Location	62 Beresford Rd Bellevue Hill NSW 2023 Australia Lot A 332414
Proposed Work	Residential Alterations and Additions
Town Planner	Michael Neustein e: City Planning Works Level 2 / 282 Oxford Street Bondi Junction NSW 2022 02 9387 1333
Geotechnical	Scott Easton e: scott.easton@douglaspartners.com.au Douglas Partners 96 Hermitage Road West Ryde NSW 2114 02 9809 0666
QS	Sabrina Tapson e: MBM Level 5 / 1 Chifley Square Sydney NSW 2000 02 9270 1000
Structural	Richard Green e: Richard Green Consulting
Hydraulic	Paul Smith e: psmith@vosgroup.com.au VOS Group Suite 802, Level 8, 99 Mount Street North Sydney NSW 2060 02 8458 2700
Surveyor	Andrew Mason e: andrew@mason.net.au Frank M Mason & Co 2 Winslow Street, Milsons Point, NSW 2061 02 9929 6233
Landscape	William Dangar Dangar Barin Smith PO Box 239 Botany NSW, 1455 02 9316 9044

Project	Drawing title	Title Sheet
331 62 Beresford Rd Bellevue Hill, NSW	Scale Date Drawn by	NTS @ A1 26/11/21 EK
Copyright Collins and Turner 2023	Drawing Number+ Revision	331_DA_000 E

Drawing title Sections Proposed
Scale 1:100 @ A1
Date 26/11/21
Drawn by EK
Drawing Number+ Revision 331_DA_411
E

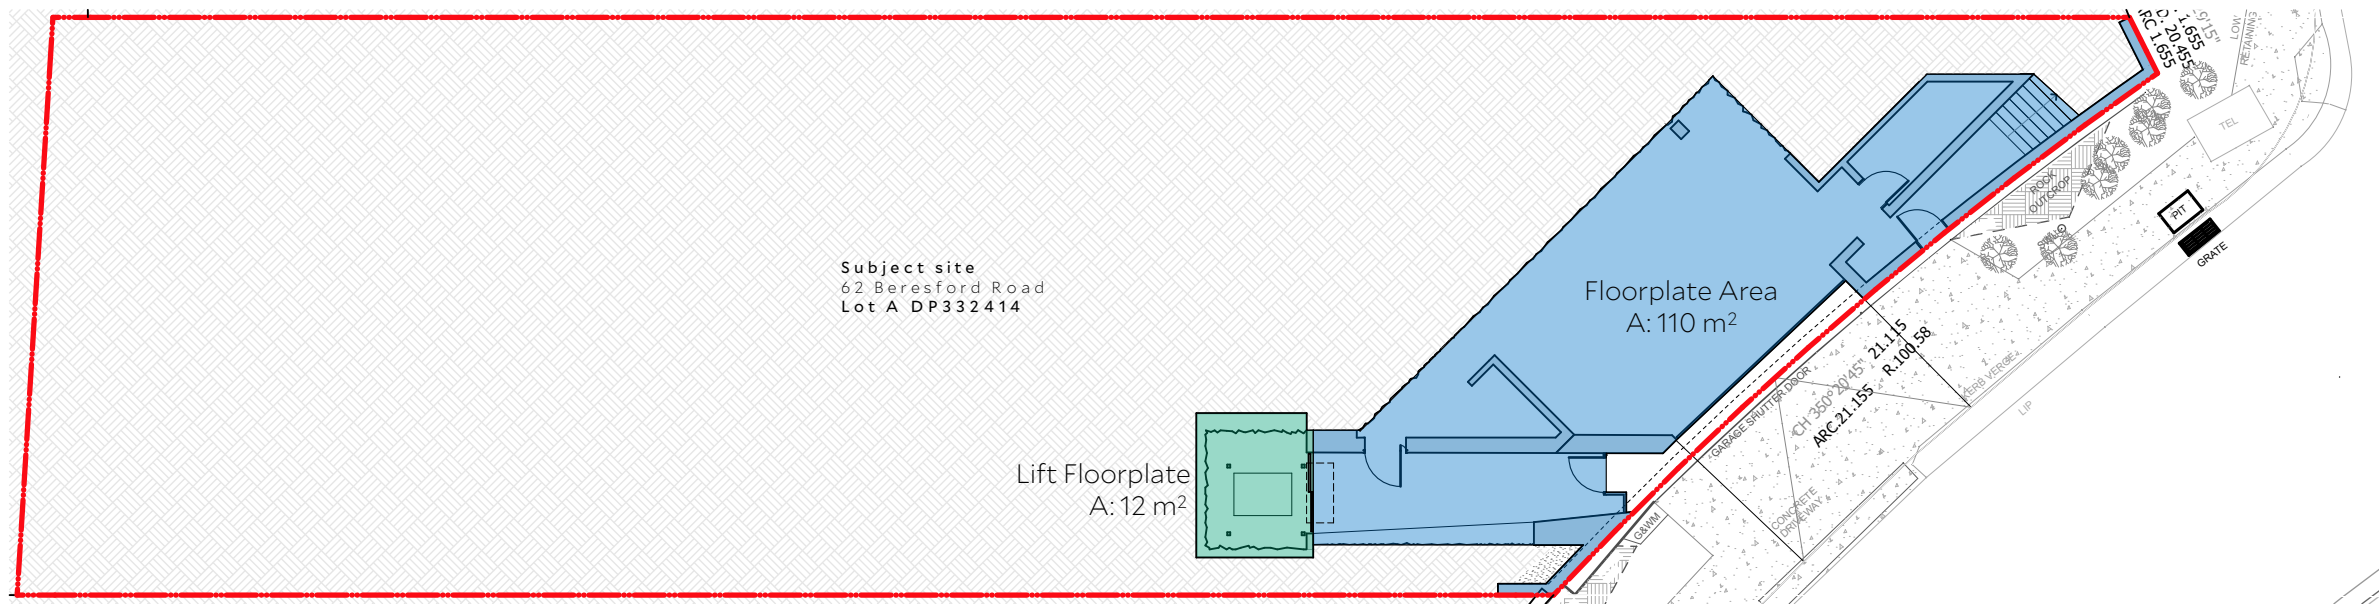
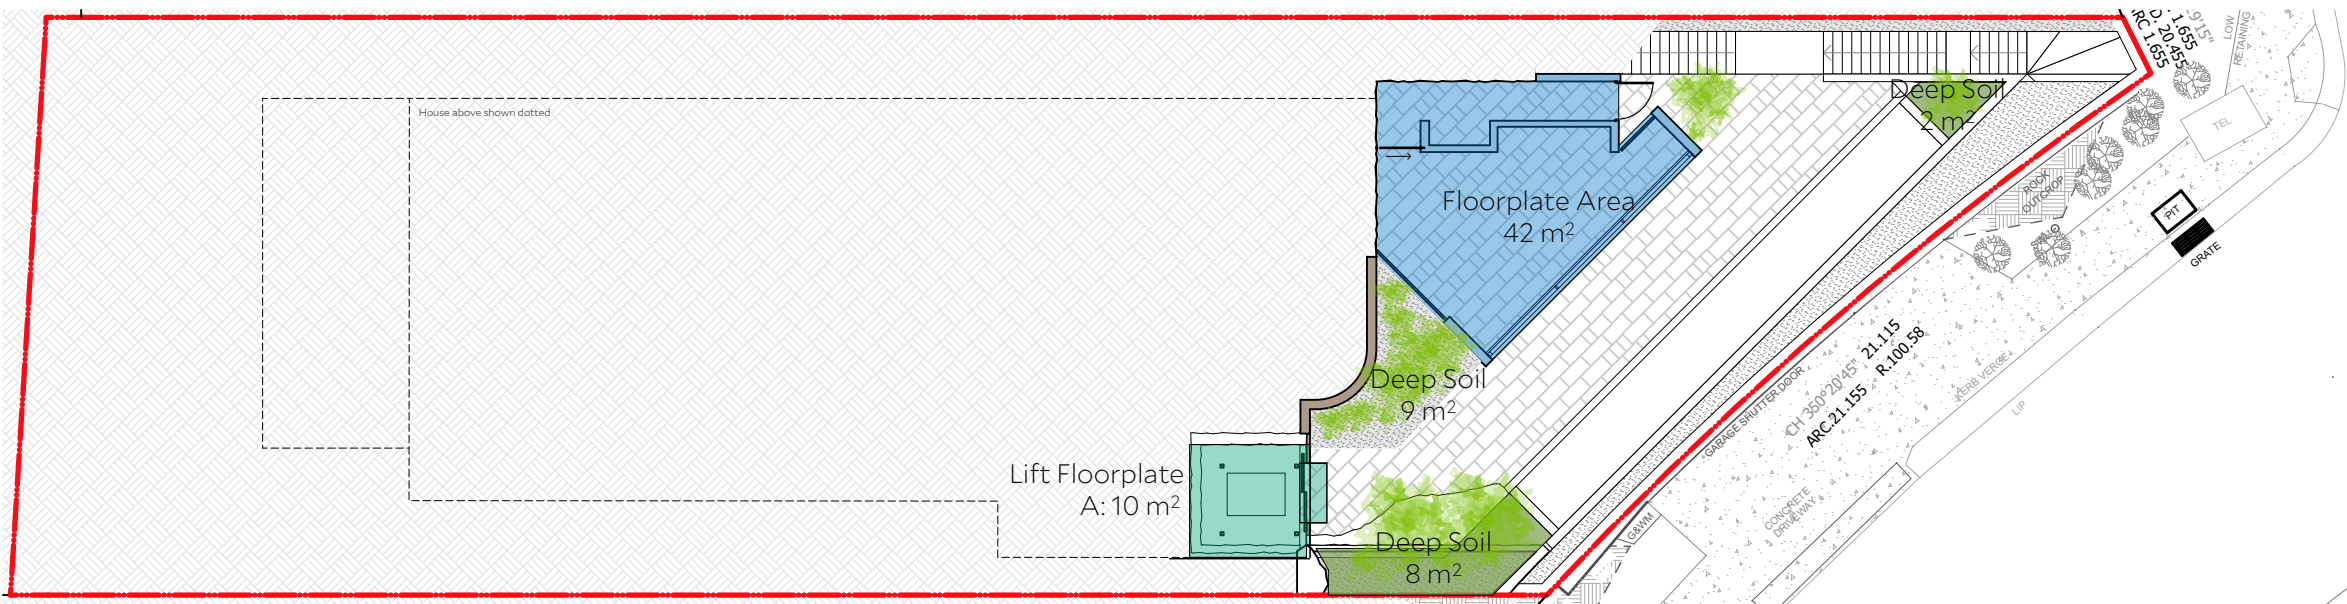
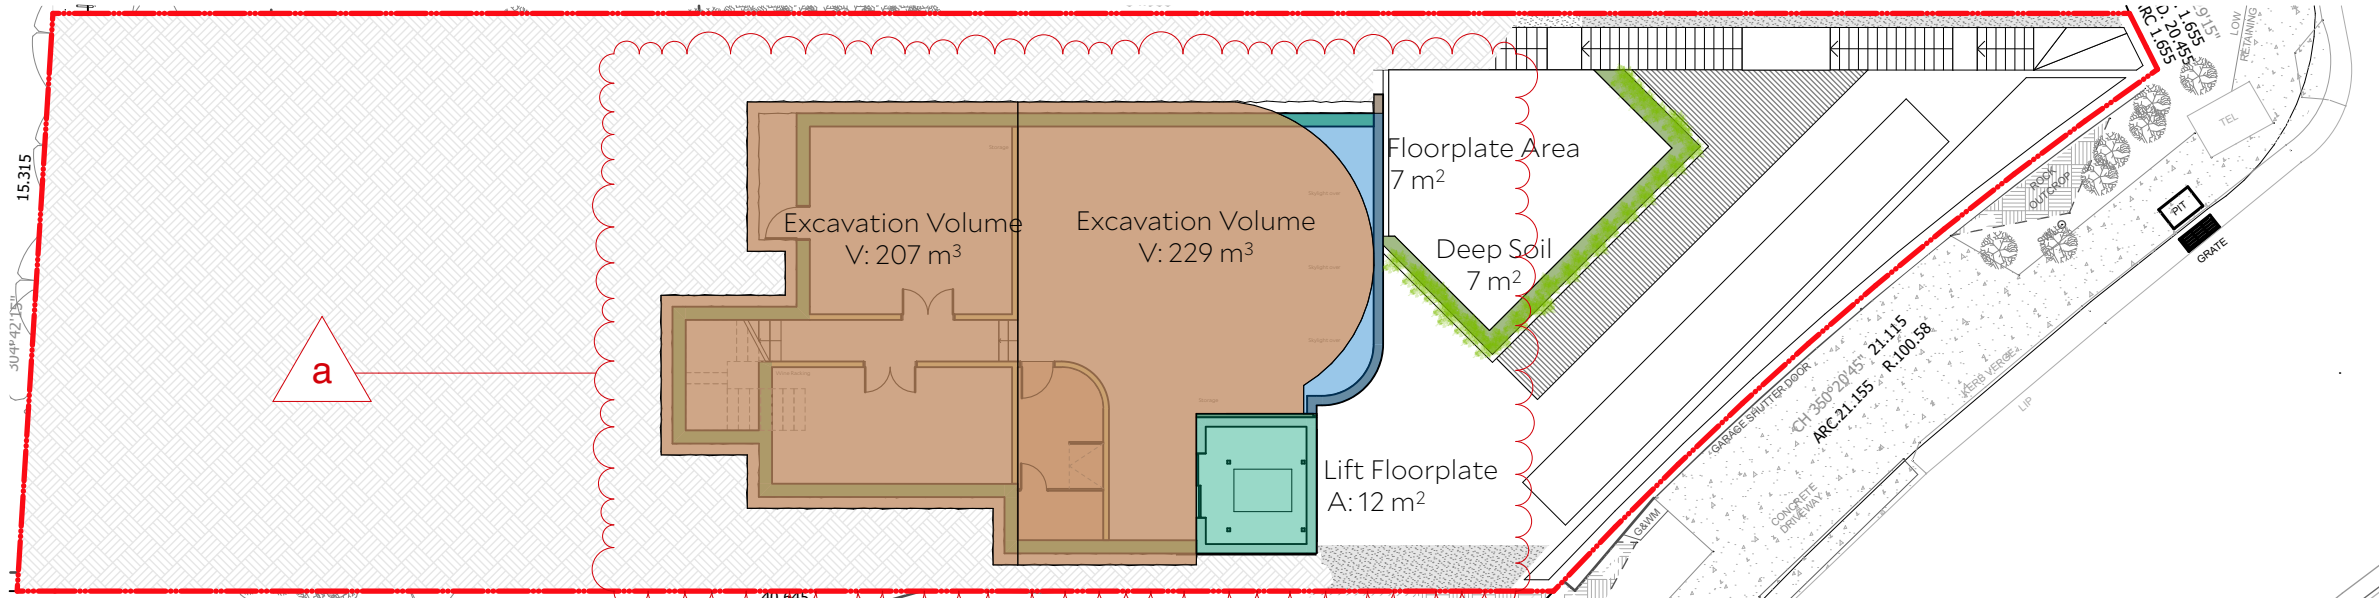
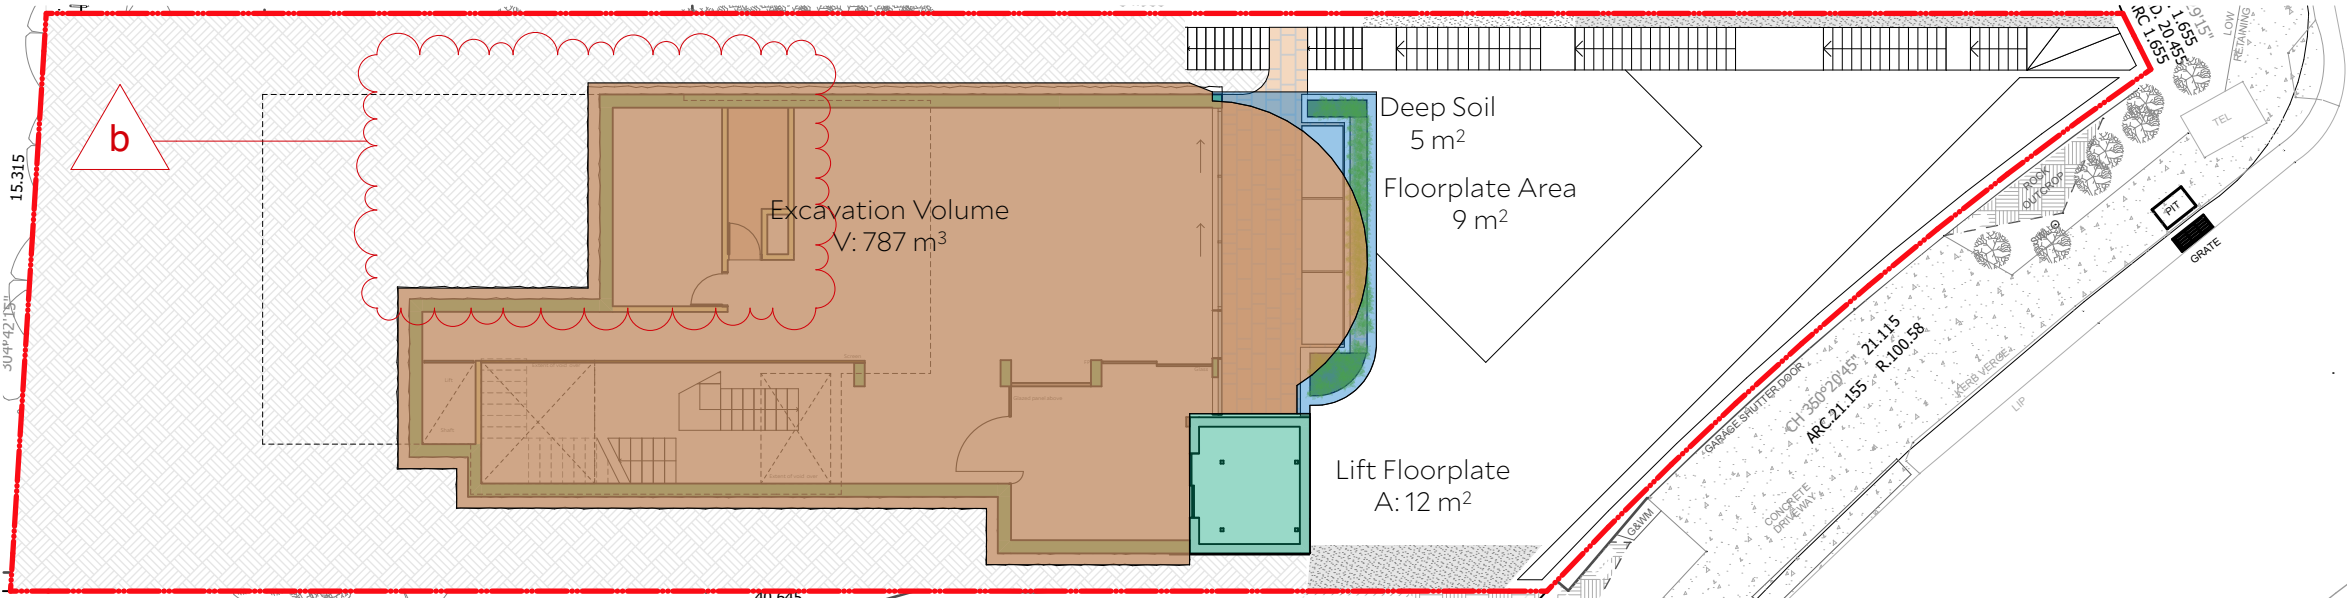
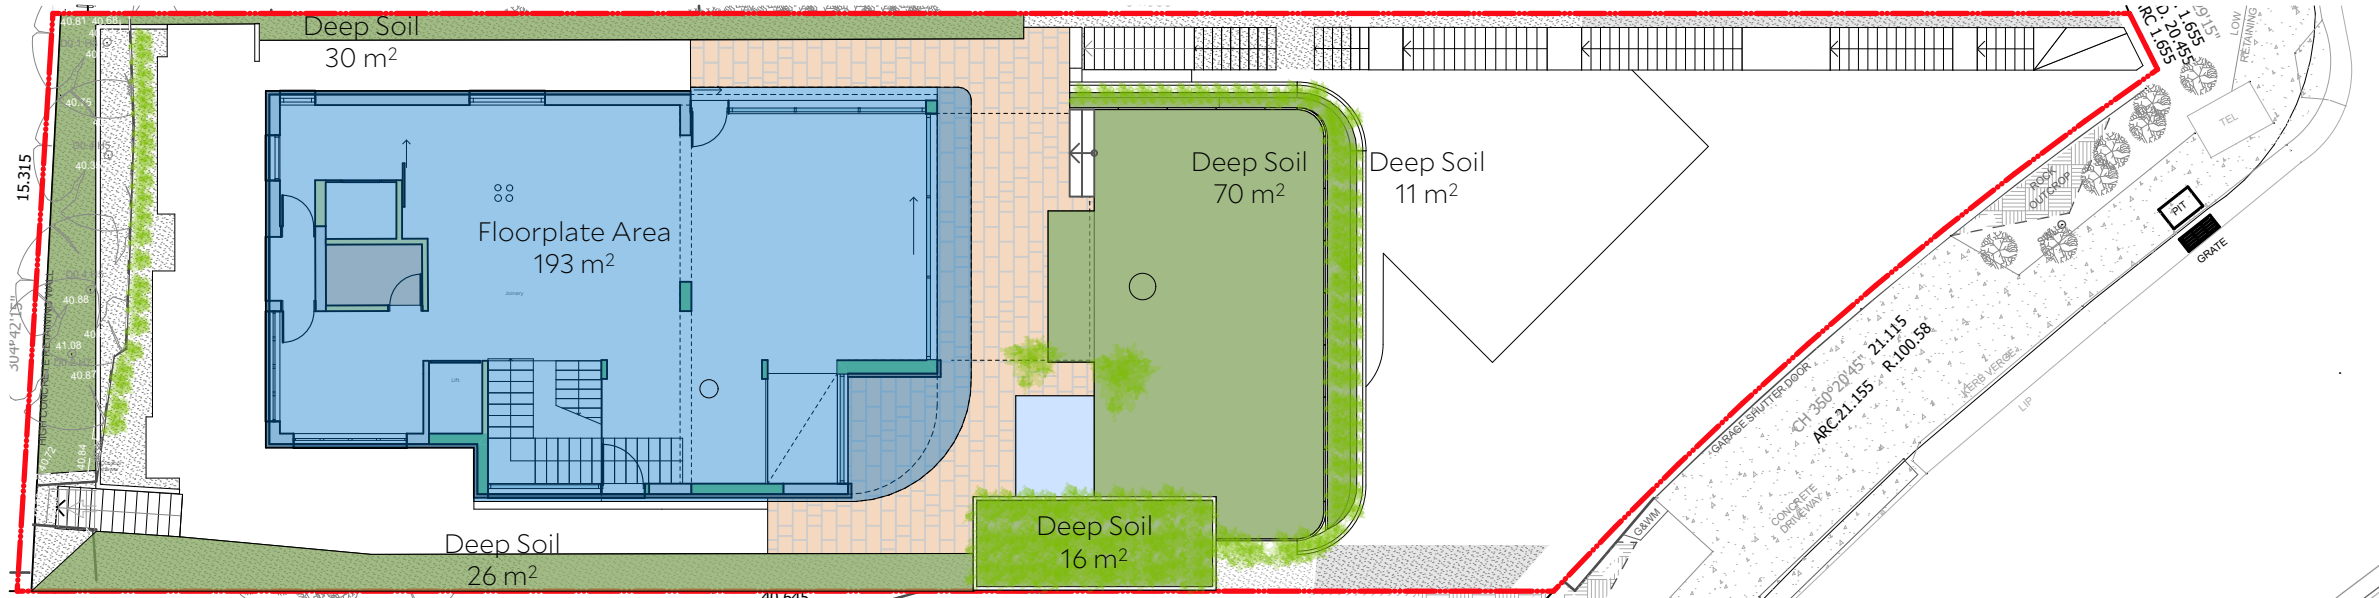
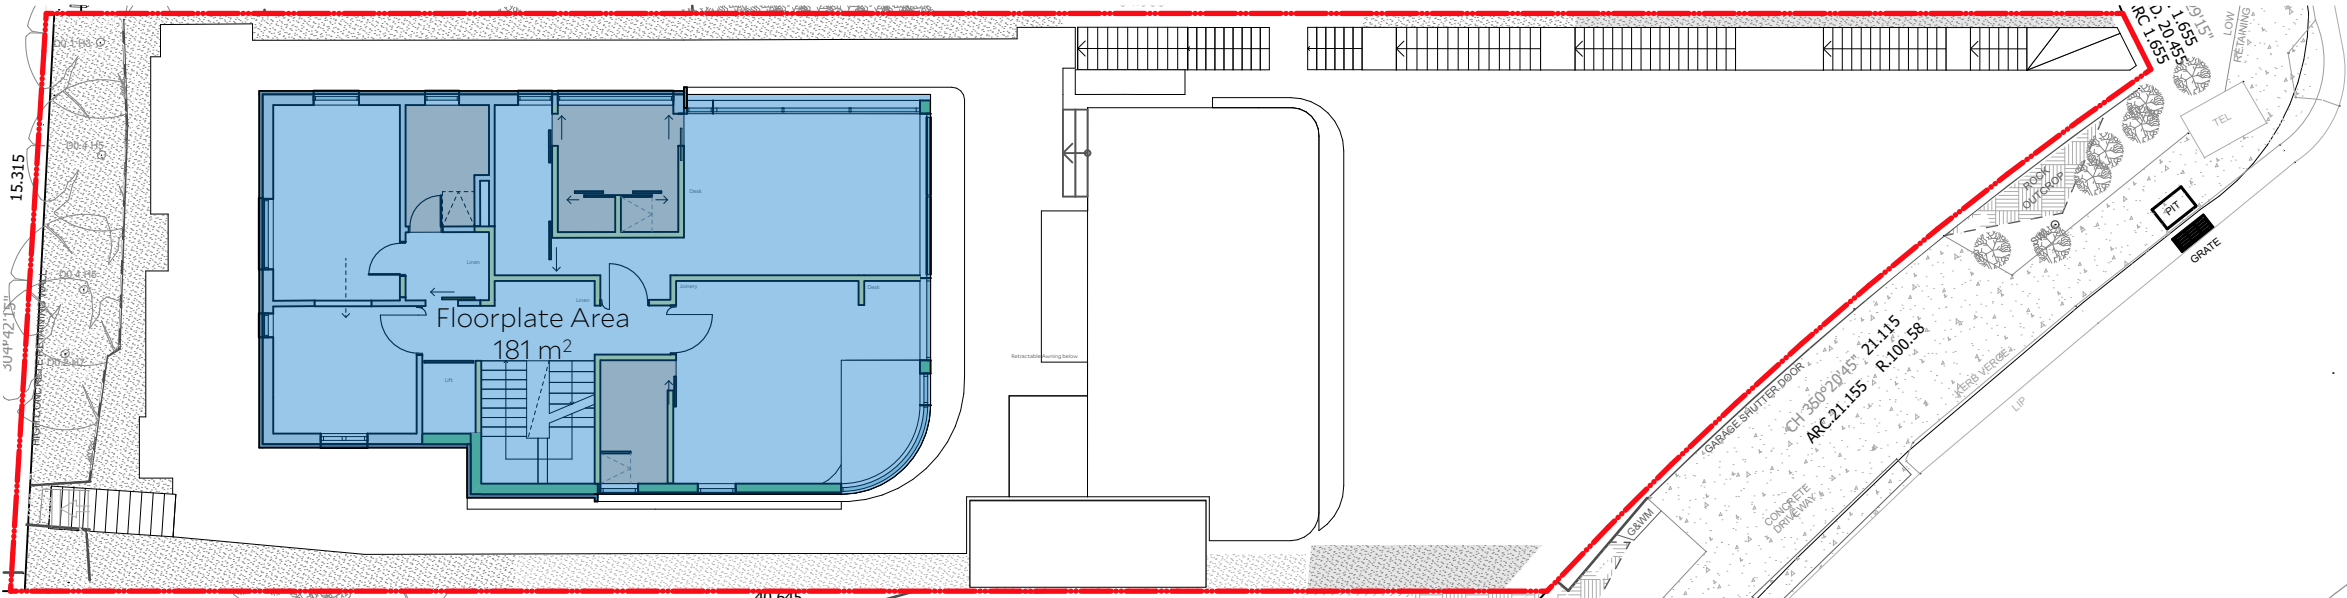
Change register
a. - Mezzanine FFL raised by 300mm, floor to ceiling height now 2400mm
- Western boundary wall moved east 500mm
c. - Southern attic wall moved south 500mm
- WC relocated
- Northern attic wall moved south 1000mm
- Upstand added to terrace perimeter to height of 500mm above FFL
- Planter box added to full perimeter of terrace.
- Perimeter walls of attic space inclined by 15°

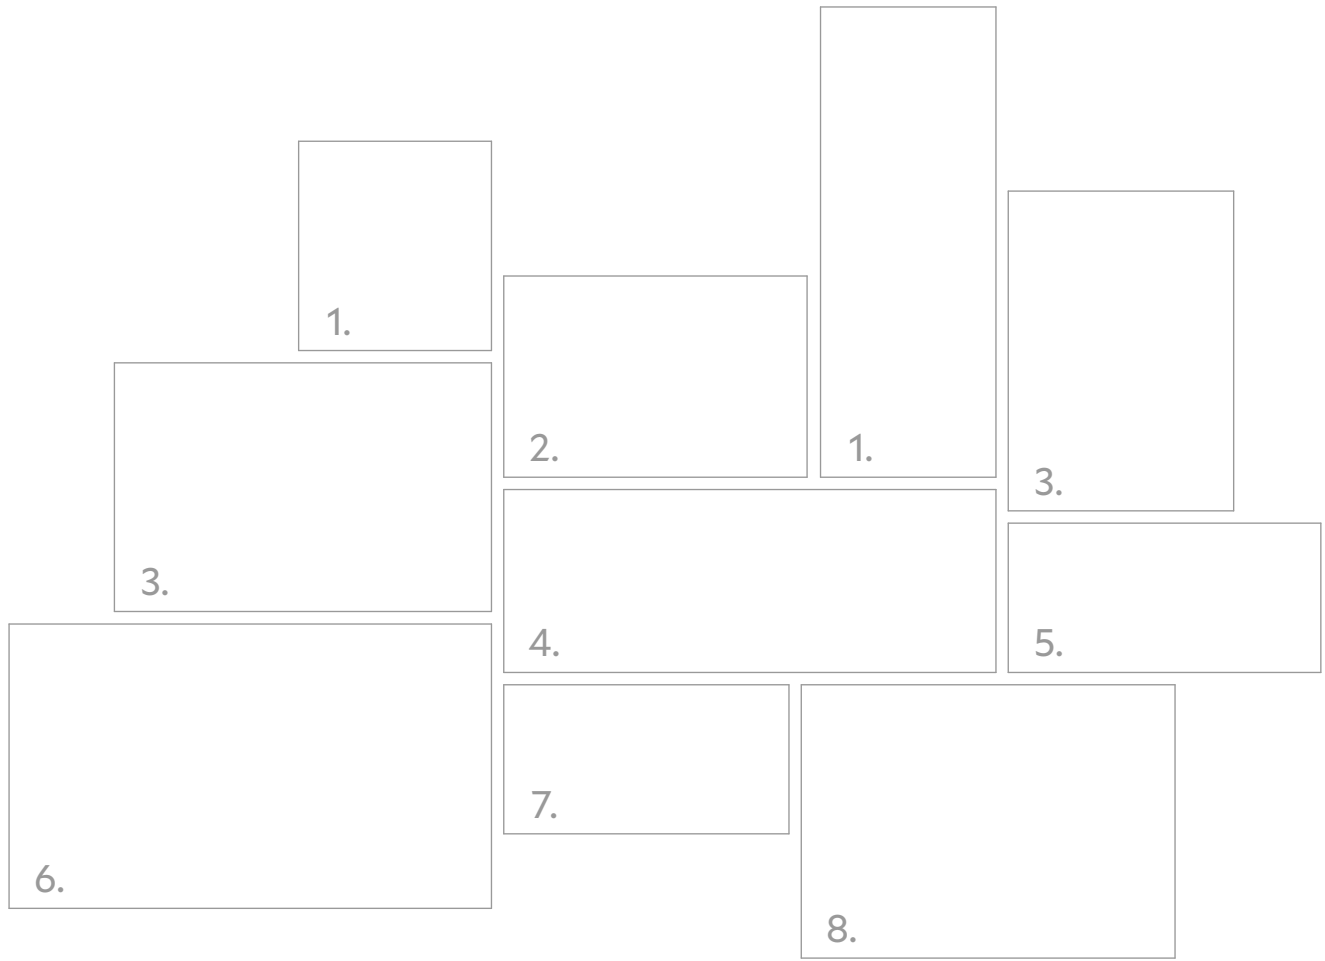
- Change register**
- a. - Mezzanine FFL raised by 300mm, floor to ceiling height now 2400mm
 - Western boundary wall moved east 500mm
 - b. Laundry and Guest WC moved north, resulting in reduction in excavation
 - c. - Southern attic wall moved south 500mm
 - WC relocated
 - Northern attic wall moved south 1000mm
 - Upstand added to terrace perimeter to height of 500mm above FFL
 - Planter box added to full perimeter of terrace.
 - Perimeter walls of attic space inclined by 15°
 - d. Landscaping removed
